135 Hickory Nut Dr.

IREDELL COUNTY HEALTH DEPARTMENT

IMPROVEMENT PERMIT / AUTHORIZATION TO CONSTRUCT / OPERATION PERMIT / EXISTING SYSTEM

PERMIT # 83-2890 PIN 4762 42 5072 16 DATE

AS-BUILT SKETCH

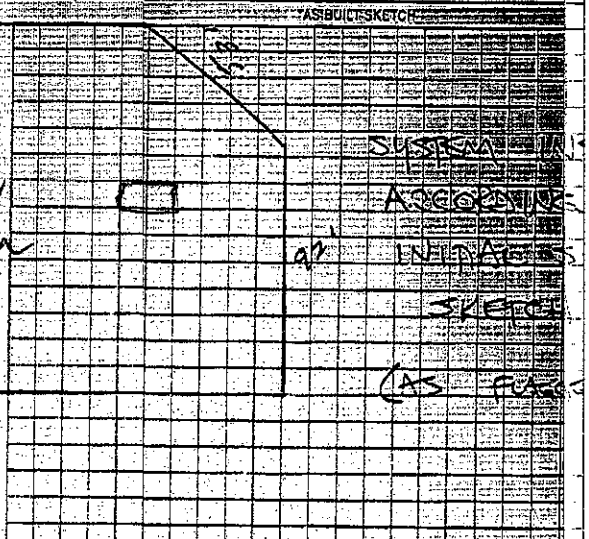
The proposed 16'x26' Attached garage addition does not appear to impact the existing septic system. 20'x20' carport

**NOTE: Carport is drawn below repair area
